SERVICE BULLETIN

Classification: FA17-005	Reference: NTB17-042	Date: April 17, 2017
-----------------------------	-------------------------	-------------------------

VERSA SEDAN, VERSA NOTE, AND MICRA SQUEAK IN FRONT SUSPENSION WHEN DRIVING OVER BUMPS

APPLIED VEHICLES: 2012 – 2016 Versa Sedan (N17)
2014 – 2016 Versa Note (E12)
2015 – 2016 Micra (K13)

Figure 1

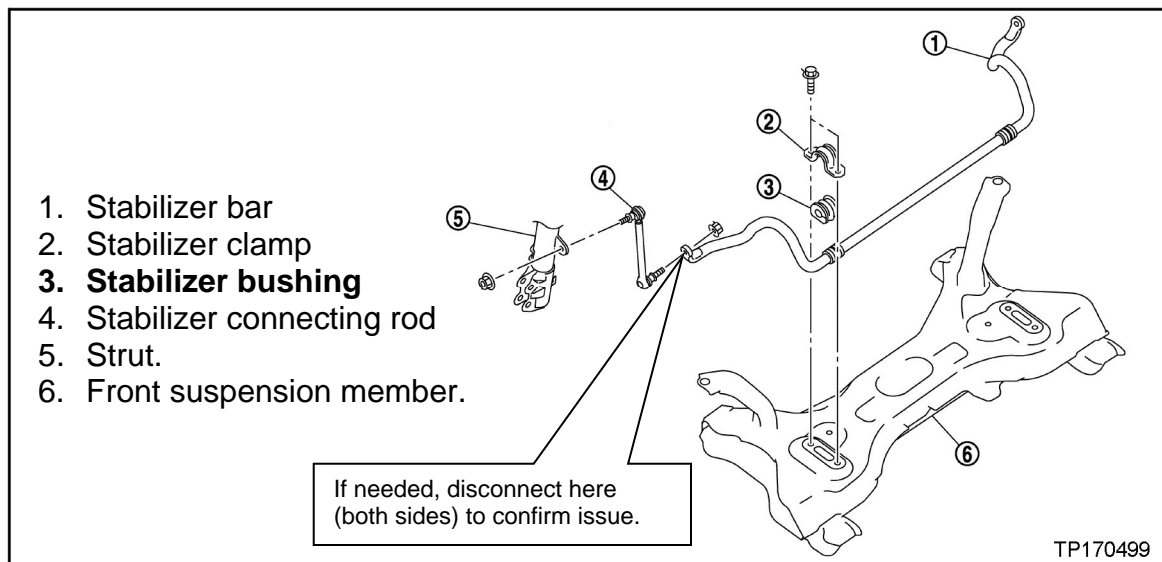
Squeak noise coming from the stabilizer bushings (see Figure 1) while driving over bumps at slow speeds,

NOTE: To confirm the squeak is coming from the stabilizer bushing, it may be necessary to:

- Disconnect the stabilizer connecting rod from the stabilizer bar – both sides (see Figure 1).
- Drive the vehicle slowly over bumps to confirm the squeak is eliminated.

Replace **both** stabilizer bushings.

- Refer to the Electronic Service Manual (ESM), section FSU-Front Suspension, for stabilizer bushing replacement.
- Stabilizer bushings are listed in the Parts Information.
